addendum no. three

OWASSO PUBLIC SCHOOLS
Owasso 8th Grade Addition

Architect: The Stacy Group
Project Number: 2407

03.26.2026

1 SYSTEMS PLAN - AREA 2
SCALE : 1/8" = 1'-0"

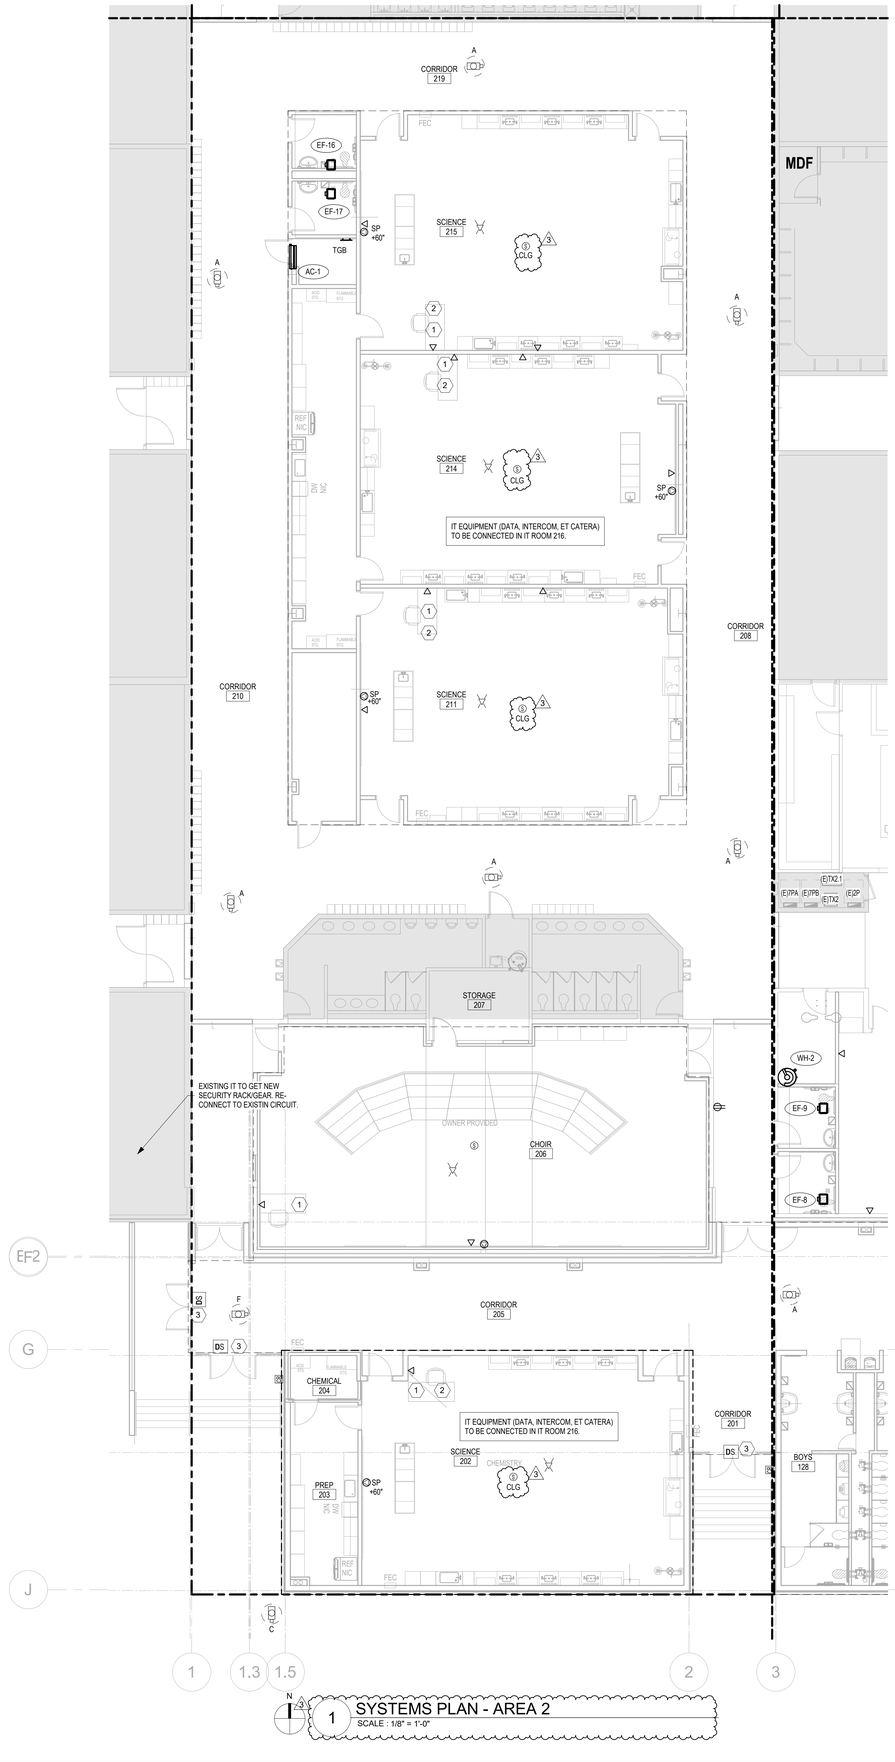
A3-50 Sheet E302 Systems Plan – Area 2: Update System Plan Notes and Keynotes.

Added Door Sensors to exterior doors.
Added speakers to Classroom 202, 211, 214, 215, and Choir Room 206.

1 / K1 KITCHEN EQUIPMENT PLAN
SCALE: 1/4" = 1'-0"

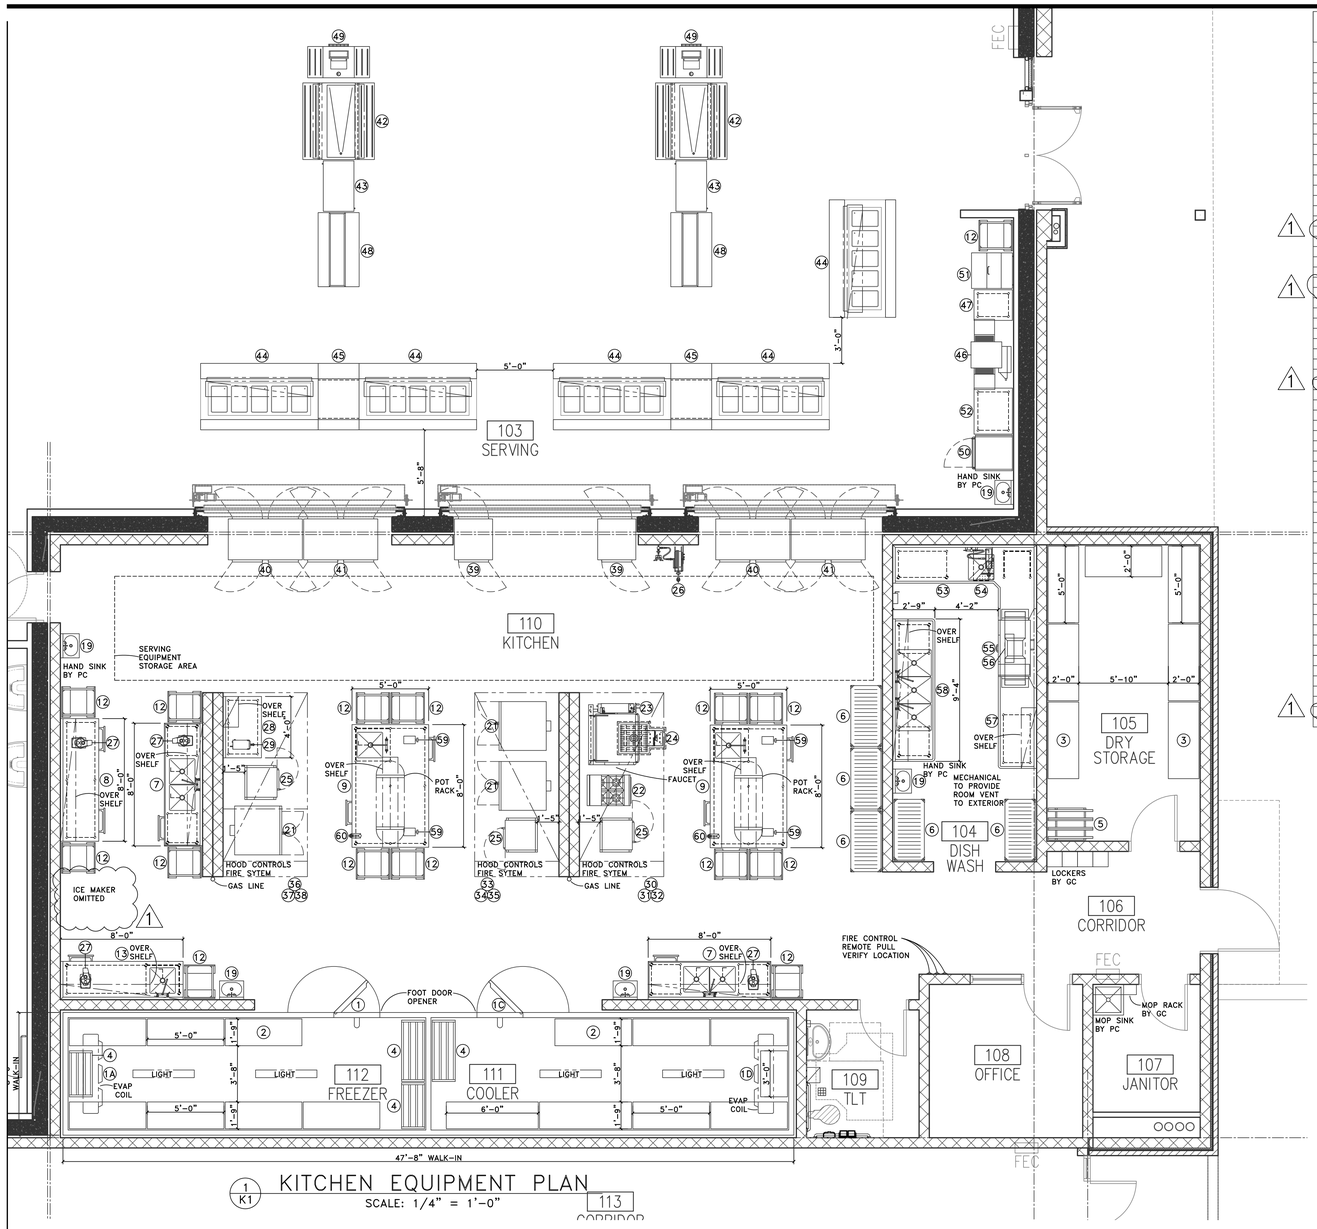
A3-52 Sheet K1 Kitchen Equipment Plan: Revise kitchen equipment. Replace sheet in its entirety.

1 / K2 KITCHEN EQUIPMENT PLUMBING PLAN

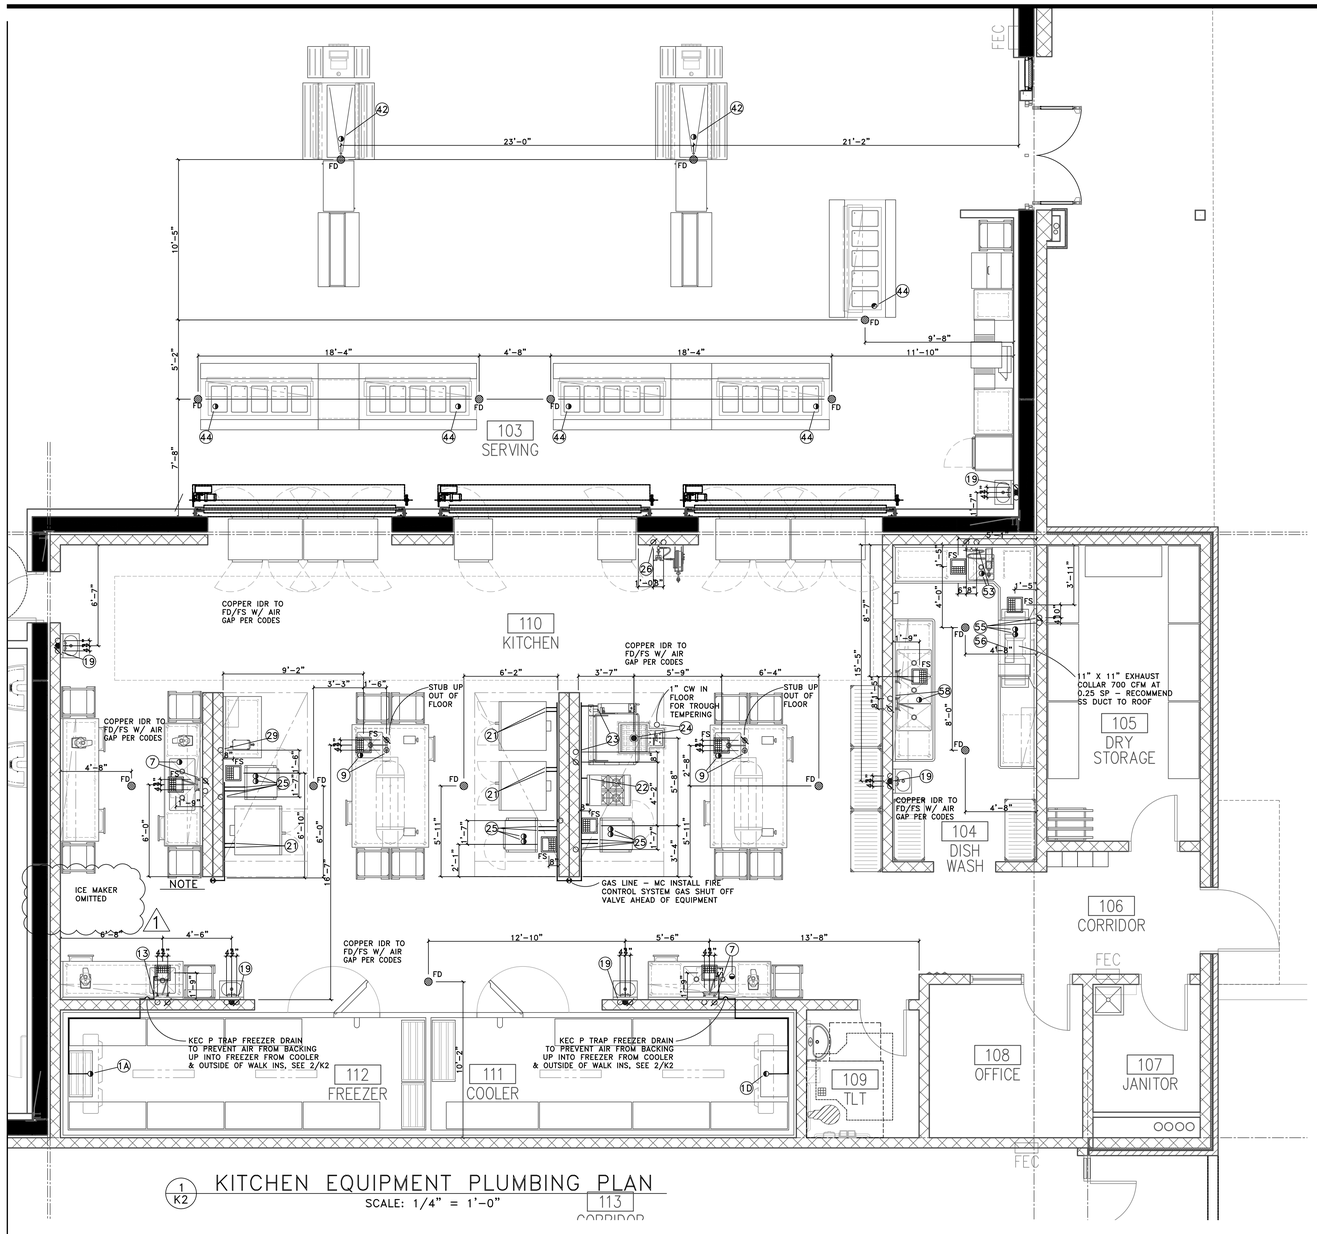
A3-53 Sheet K2 Kitchen Equipment Plumbing Plan: Revise Kitchen Equipment Plumbing Requirements. Replace sheet in its entirety.

1 K3 KITCHEN EQUIPMENT ELECTRICAL PLAN
SCALE: 1/4" = 1'-0"

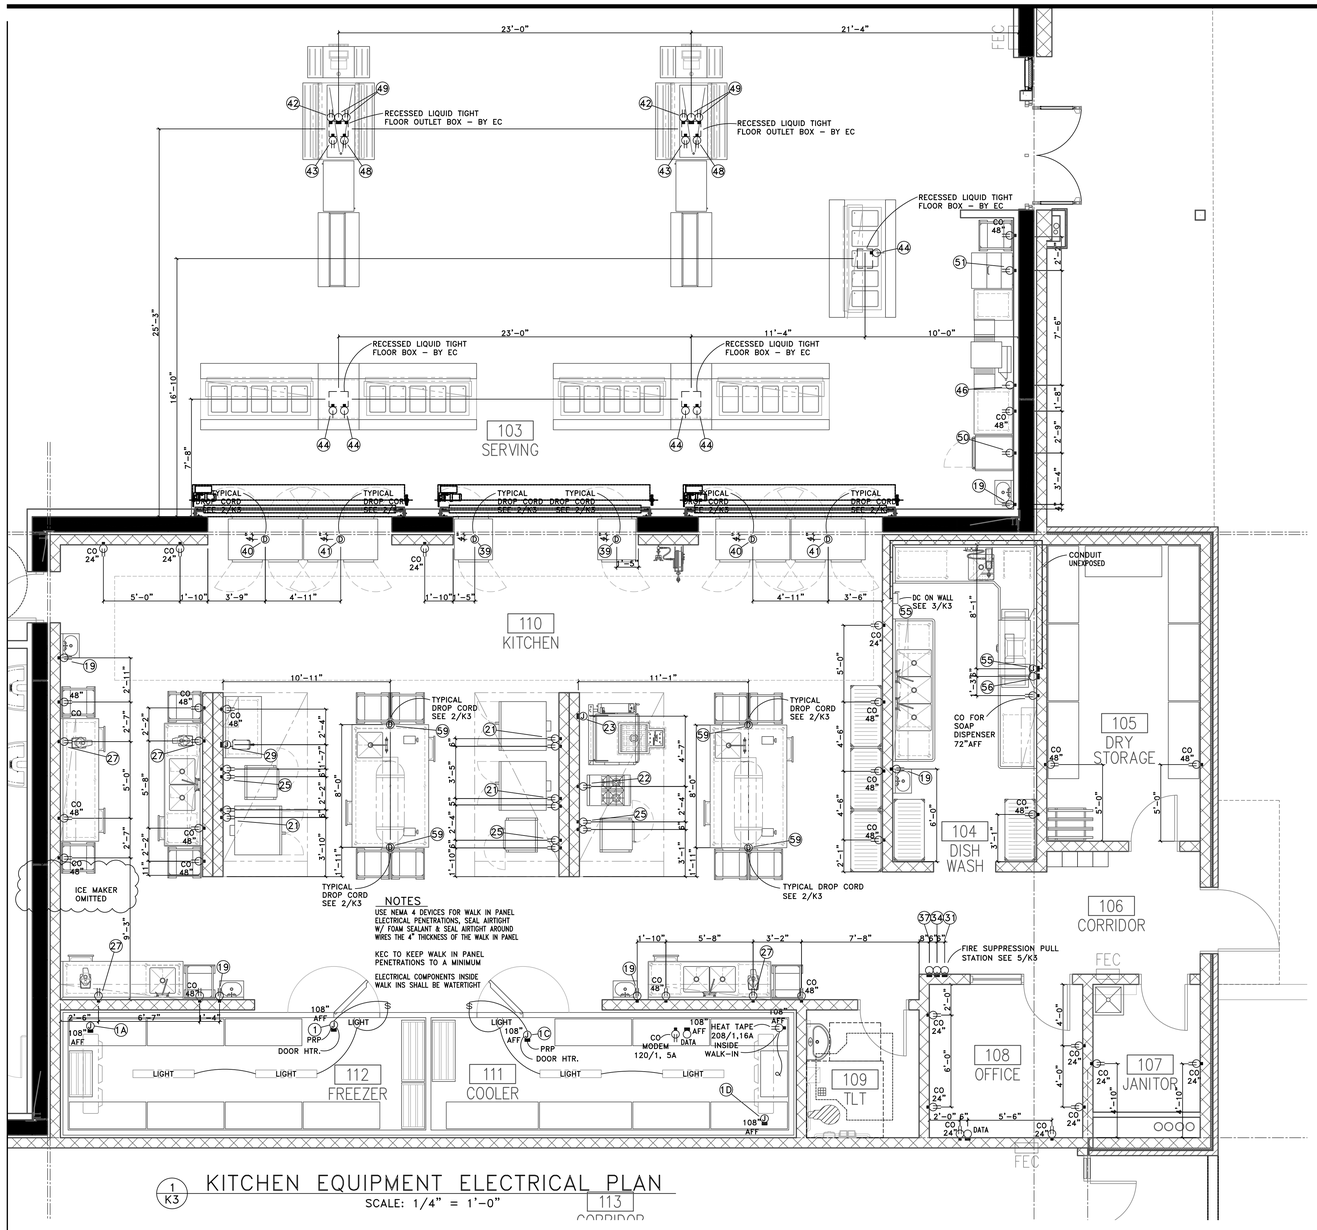
A3-54 Sheet K3 Kitchen Equipment Electrical Plan: Revise Kitchen Equipment Electrical Requirements. Replace sheet in its entirety.
